STAFF RECOMMENDATION
3620 Meadowbrook Avenue
January 15, 2020

Application: New Construction – Addition
District: Richland-West End Neighborhood Conservation Zoning Overlay
Council District: 24
Base Zoning: RS7.5
Map and Parcel Number: 104050265
Applicant: Preston Quirk, architect
Project Lead: Jenny Warren, jenny.warren@nashville.gov

<p>Description of Project: Application for new construction including an addition and enclosing an existing carport. The addition will be less than twenty feet (20') from the garage.</p> <p>Recommendation Summary: Staff recommends approval of the proposed new construction with the conditions that:</p> <ol style="list-style-type: none">1. Staff approve the final roofing color, doors, windows, garage doors and the material of the trim, porch steps and porch posts; and2. The HVAC shall be located behind the house or on either side, beyond the mid-point of the house; <p>Finding that it meets the design guidelines for the Richland-West End Neighborhood Conservation Zoning Overlay.</p>	<p>Attachments A: Photographs B: Site Plan C: Elevations</p>
----------------------------------------------------------------------------------------------------------------

Figure 3: Two story rear addition on right, one story screened porch at center

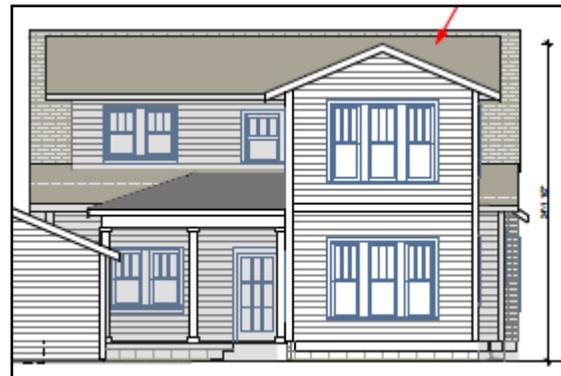
Height & Scale: The addition includes a two-story rear gabled portion and a one story screened porch (Figures 2 & 3). The two-story portion is inset two feet (2') from the left side wall of the house and its ridge sits approximately one foot (1') below the peak of the primary side-gable of the historic house. This portion is about nineteen feet (19') deep, increasing the depth of the house to a total of about seventy feet (70') deep, inclusive of the front porch. The screened porch is only one-story, behind the one and a half story house, and is inset from the right side wall by about six feet (6').

Roof form: The two-story addition will have a rear-facing gabled roof with a pitch of approximately 5/12 (Figure 3). The one-story screened porch will have a hipped roof

with a 4/12 pitch. Both of these roof forms are commonly seen historic roof forms and the pitches are appropriate to the historic house.

Figure 5: Five foot separation between back of screened porch and front of garage.

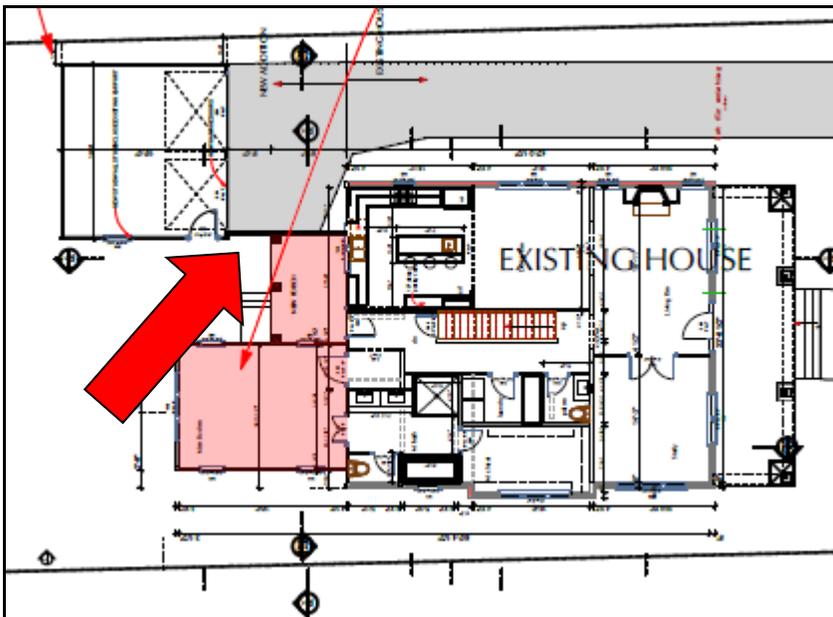
The design guidelines require a twenty foot (20') distance between an outbuilding and the primary structure. The applicant is proposing a five foot (5') separation (Figure 5). In the past, the Commission has reduced the required separation when there were special circumstances or site restraints. Staff finds that the proposed five foot (5') separation could be appropriate in this case, because the existing building is only this close to the

house at the far corners of each (Figure 5). While outbuildings tend to be located along the alley, the guidelines state that “Outbuildings should be situated on a lot as is historically typical for surrounding historic buildings.” Despite there being a rear alley, on this block many of the houses have existing curbs cuts and garages that are closer to the rear of the house and are accessed from the street rather than off of the alley. The 1931 Sanborn map of this block shows this condition clearly (Figure 6). As such, the existing location of the garage may be appropriate in this case, even at less than twenty feet (20’) from the back of the house.

Figure 7: Site plan of carport/garage

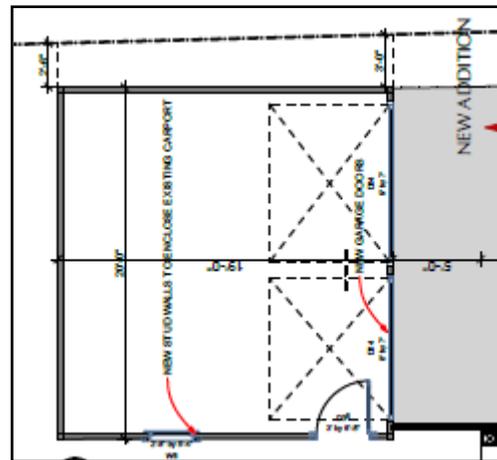
On the right side, the garage sits approximately three feet (3’) from the side property line at the front corner. However, the back corner sits about two feet, six inches (2’6”) from the side property line (Figure 7). Base zoning requires a minimum of three feet (3’). Staff finds that this location is appropriate in this case because the permitted carport is already existing.

Staff finds that the project meets section II.B.1.h of the design guidelines.
